Representation on the Further Environmental Information

Application: Construction and operation of up to 12 wind turbines with a maximum height to the tip of the blade of 180 metres (above ground level), with associated infrastructure, land at and adjacent to Scout Moor Wind Farm, Rossendale and Rochdale (Further Environmental Information)

References: Rossendale 2025/0267; Rochdale 25/00680/FUL

From: County Councillor Tom Pickup, Padiham and Burnley West division, Lancashire County Council

Figure 1. Cumulative zone of theoretical visibility, Scout Moor II as revised (12 turbines) with Calderdale Energy Park (34)

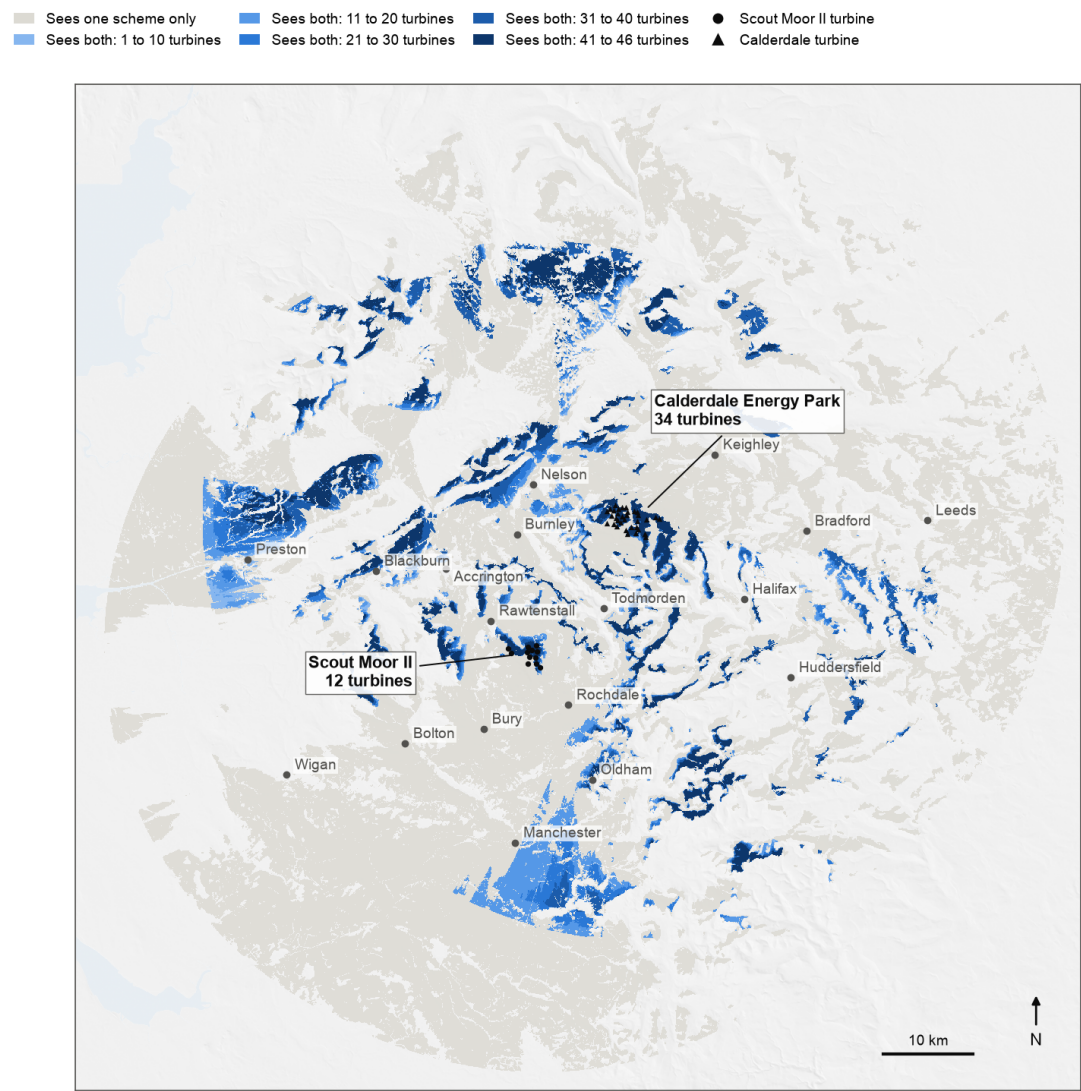
699 km² of land would theoretically see turbines of both schemes

Cumulative zone of theoretical visibility, Scout Moor II as revised (12 turbines) with Calderdale Energy Park (34). 698.9 km² sees turbines of both schemes; 685.4 km² in the applicant's own software (Appendix A, A4). Bare earth, blade tip, eye height 2 m, $k = 0.075$, 45 km. Contains OS data © Crown copyright and database right 2026.

Figure 2. Land seeing both schemes: the 17-turbine layout (v1r) against the 12-turbine layout (v2), with Calderdale Energy Park unchanged

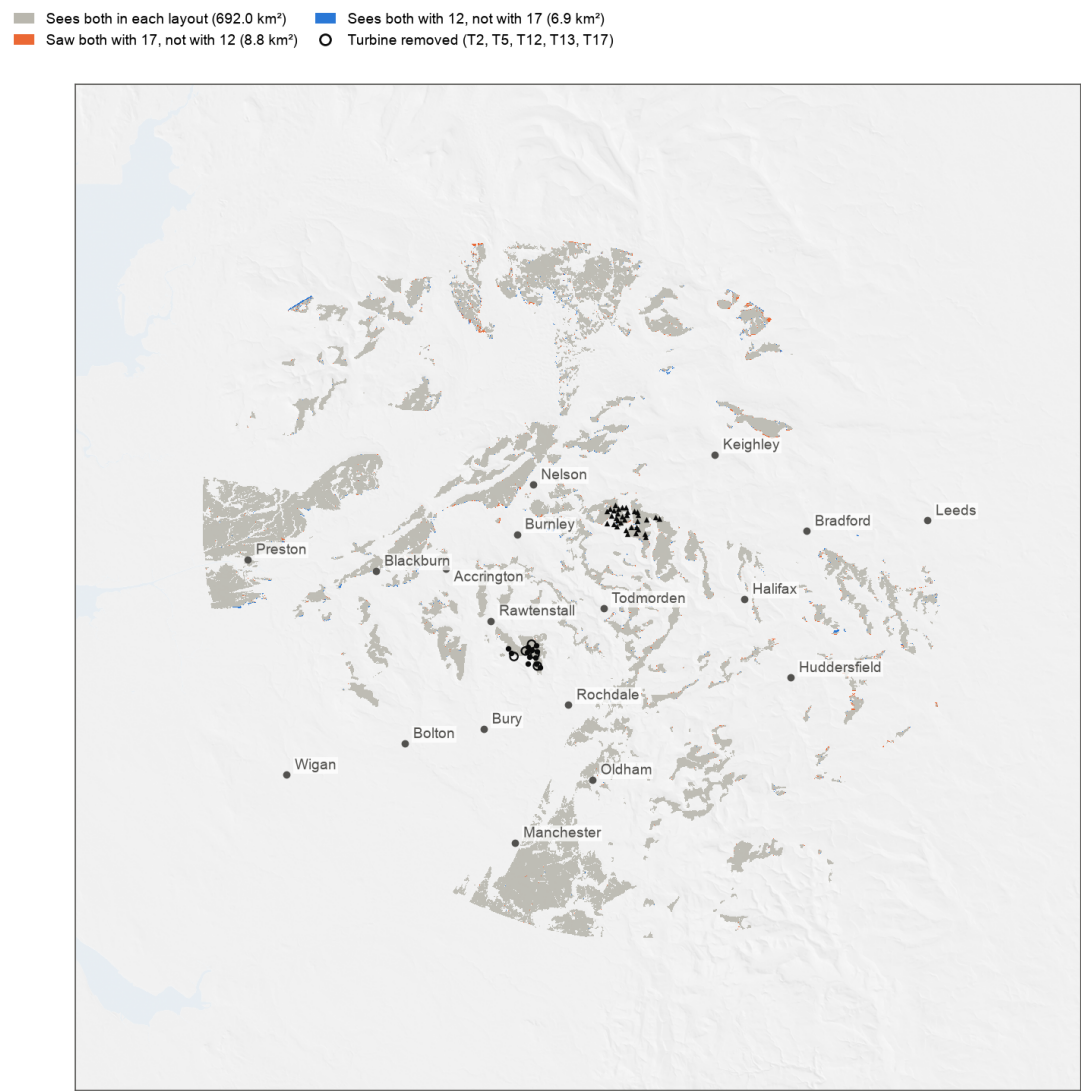
Removing five turbines changed the shared view by 1.9 km² of 701 km²

Change in the overlap from 17 to 12 turbines, under the same method: 8.8 km² left, 6.9 km² entered, 692.0 km² common to both.

Scout Moor II and Calderdale Energy Park: where both may be seen, applicant's Figure 11.16 against our model

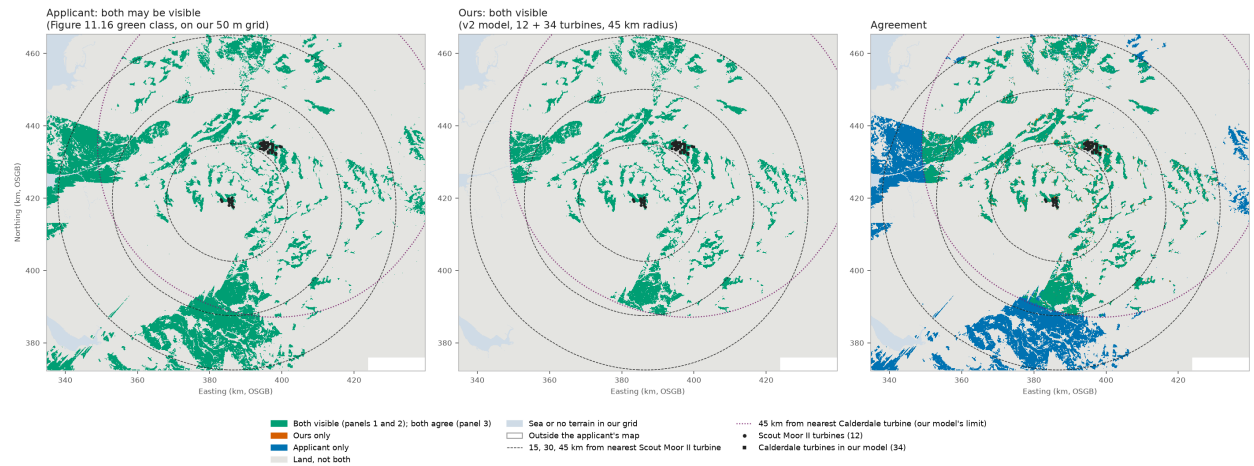
Within 45 km of the nearest Scout Moor II turbine, on land inside the applicant's map: applicant 1188 km², ours 699 km², overlap 657 km², IoU 0.53; 94% of ours lies inside theirs and 55% of theirs inside ours. Where both models compute (within 45 km of both schemes): IoU 0.88.

The applicant's Figure 11.16 'both may be visible' class on the 50 m grid (left), this model (centre), and where they agree (right). Where both models compute, intersection over union 0.88.

Figure 11.16 plots 65 Calderdale turbine markers, although its key says the PEIR layout of 7 April 2026, which has 34. Calderdale's PEIR Chapter 5, para 5.7.1, records an initial 2023 layout of "up to 65 turbines". The applicant's Calderdale visibility class agrees best with the 34-turbine layout (intersection over union 0.92, against 0.85 to 0.87 for the 65 marker positions run through this model at 150, 175 or 200 m; pipeline/grids/fig1116_layout_check.json), so

the analysis appears to use the right layout and the plotted symbols the wrong one. The applicant may wish to correct the figure.
